Groundwater Transfer Review Summary Form

Transfer/PA # T- 13542

Ground Water Review Form:

Applicant Name: MF Beef Bend, LLC

Well location Map

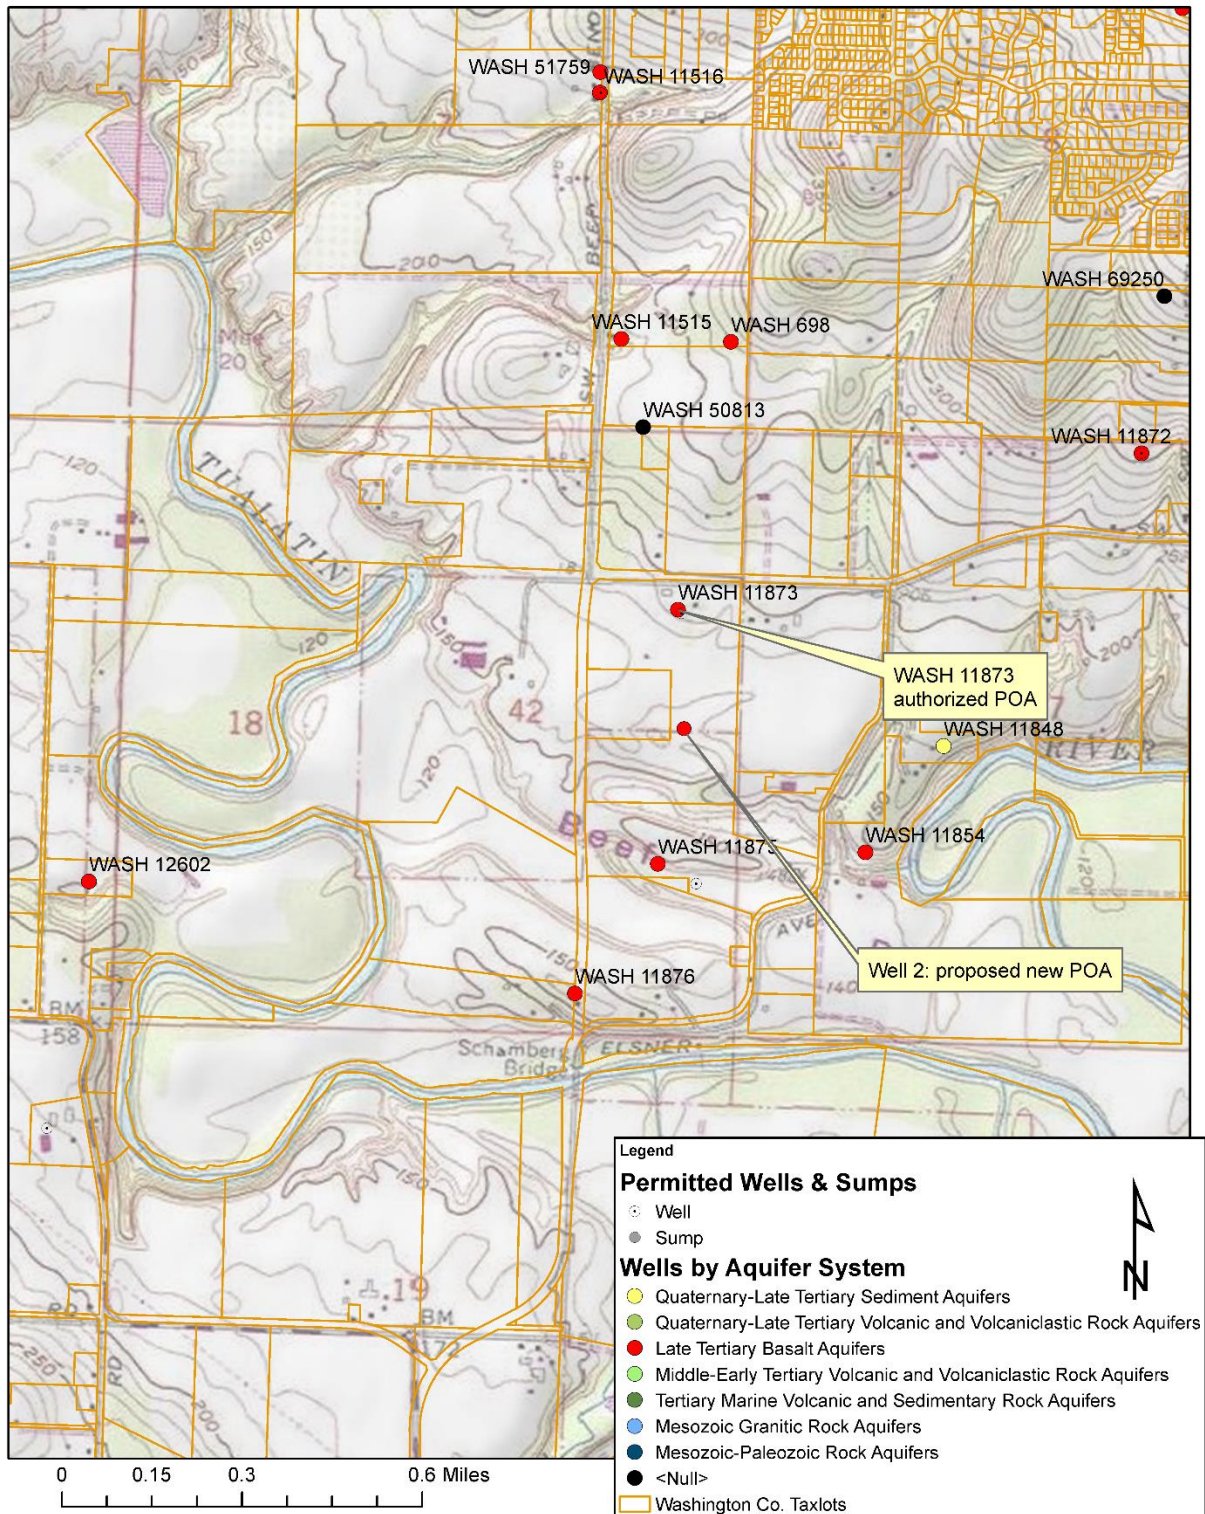
-
1. Basic description of the changes proposed in this transfer: T-13542 proposes to change the place of use, character of use and add a point of appropriation to Certificate 51171. The currently authorized well is WASH 11873, a 392 foot deep well that accesses an aquifer within the Columbia River Basalt Group (CRBG). This right is located within the Cooper-Bull Mountain Critical Groundwater Area (CGWA).

2. Will the proposed POA develop the same aquifer (source) as the existing authorized POA?
☒ Yes ☐ No Comments: The proposed APOA is described in the application as a 400 foot deep well that will access an aquifer within the CRBG. Groundwater within this portion of the CRBG is managed as a single aquifer per the CGWA Order (Special Order Vol. 24, Page 370).

Well pumping drawdown estimates

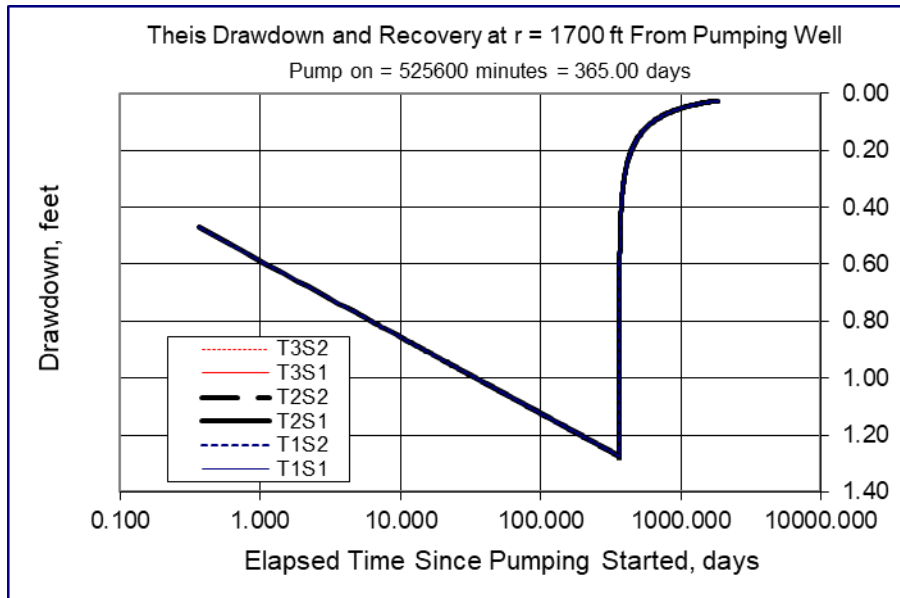
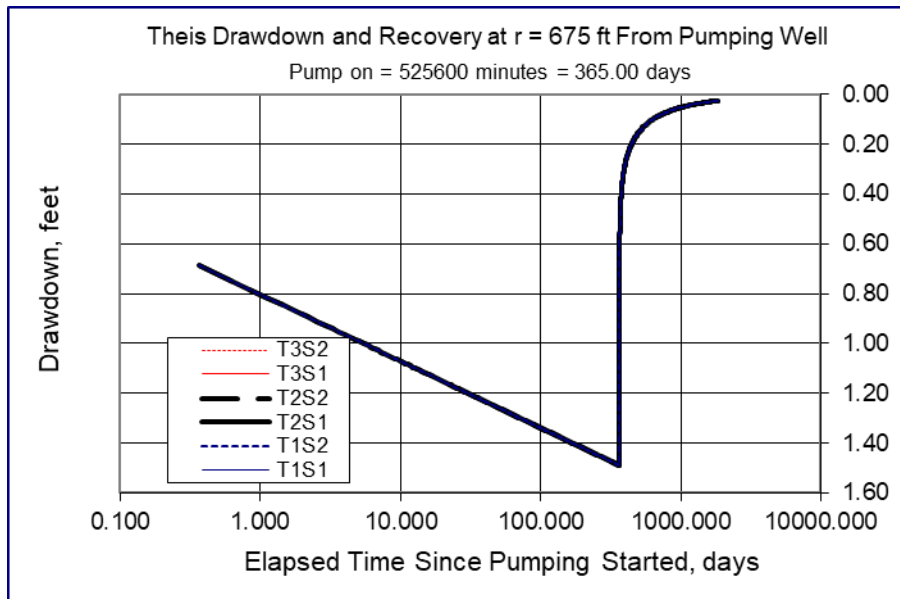
4. a) Will this proposed change, at its maximum allowed rate of use, likely result in an increase in interference with **another ground water right**?
☒ Yes ☐ No Comments: The new POA is 1200 feet closer to the southern taxlot boundary, which will increase drawdown by approximately 0.2 feet at the property line.

☐ Yes ☒ No If yes, explain: A reasonably efficient, fully penetrating well in this aquifer should have at least 200 feet of water above the bottom of the hole. A drawdown increase of 0.2 feet will not prevent access to sufficient groundwater rates or volumes.
